REMARKS

U.S. Patent Application No.: 10/716,596
Attorney Docket No.: 57941.000063
Client Reference No.: RA001.2003.2.C.US

FIG. 16

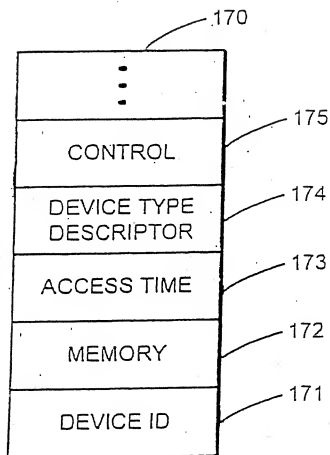
Please add Figure 16 by adding the new drawing sheet containing added Figure 16 as indicated in attached Appendix C.

The Examiner asserts that the controller and details of the controller as recited in claims 169-181 and 185-188 must be shown or cancelled from the claims.

Applicants respectfully submit that the claimed controller device and its details are already well supported in the Figures. For example, Figure 2 shows a CPU 11 having a device interface 161. Such a CPU 11 may be a controller device as supported in the specification (see page 13, lines 13-16). Also, Figures 10-14 show features of the device interface 161 in accordance with an embodiment of the claimed invention, including input receiver circuitry 71 and 72 and output driver circuitry 76 (see from page 53, line 4, to page 59, line 2).
